ENVIRONMENTAL PROTECTION COMMISSION[567]

Adopted and Filed

Pursuant to the authority of Iowa Code section 459.103, the Environmental Protection Commission hereby amends Chapter 65, "Animal Feeding Operations," Iowa Administrative Code.

The amendments modify the construction design standards for formed manure storage structures as prescribed by 2002 Iowa Acts, chapter 1137. The standards include upgraded requirements for formed manure storage structures in karst areas and separate construction design standards for formed manure storage structures that store manure exclusively in a dry form.

APPENDIX D, FIGURE D-1
MONOLITHIC FOOTING FLOOR DETAIL*

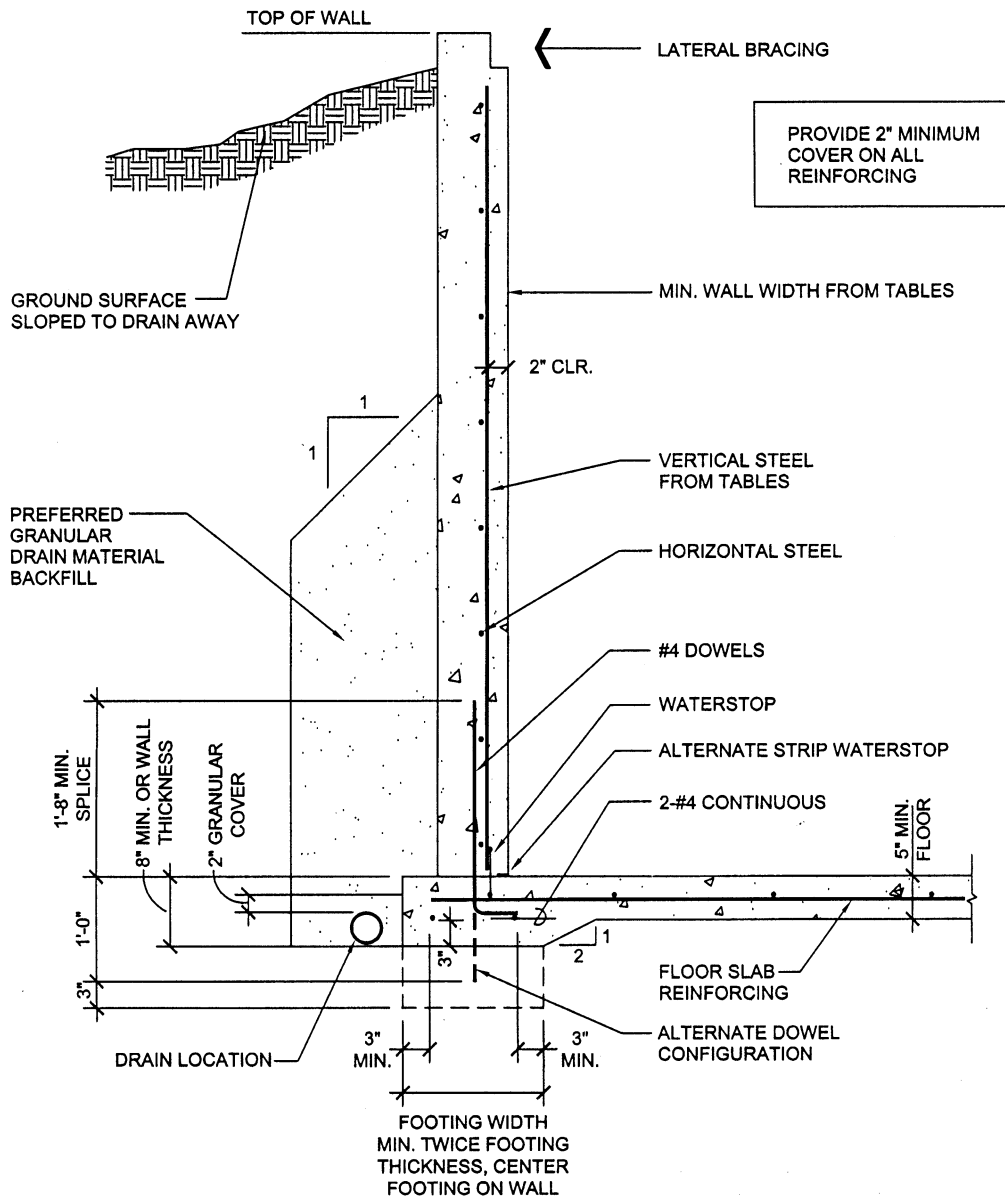
footings. Comments recommended that the drain tile be installed right at the footing elevation, instead of at 2 feet below the footing, as initially proposed. A new Figure D-1 has been added at the end of Chapter 65 to illustrate the ideal location of the drain tile. In addition, the option to install fabric around the drain tile or a combination of fabric and granular material has been added. This specification, however, is only for a formed manure storage structure with a design not sealed by a PE or an NRCS engineer, due to the reasons explained in "2" above.

13. The waterstop and keyway requirements have been modified as follows. The keyway requirement has been eliminated. The waterstop requirements in 65.15(14)"a"(1), numbered paragraph "3," and 65.15(14)"a"(2), numbered paragraph "13," have been expanded to allow rolled bentonite and to include a reference to Appendix D, Figures D-1 and D-2, at the end of Chapter 65 to better illustrate installation.

2. When the groundwater table, as determined in 65.15(7)"c," is above the bottom of the formed structure, a drain tile shall be installed along the footings to artificially lower the groundwater table pursuant to 65.15(7)"b." The drain tile shall be placed within 3 feet of the footings as indicated in Appendix D, Figure D-1, at the end of this chapter and shall be covered with a minimum of 2 inches of gravel, granular material, fabric or a combination of these materials to prevent plugging the drain tile.

13. All construction joints in exterior walls shall be constructed to prevent discontinuity of steel and have properly spliced rebar placed through the joint. Waterstops shall be installed in all areas where fresh concrete will meet hardened concrete as indicated in Appendix D, Figures D-1 and D-2, at the end of this chapter. The waterstops shall be made of plastic, rolled bentonite or similar materials approved by the department.
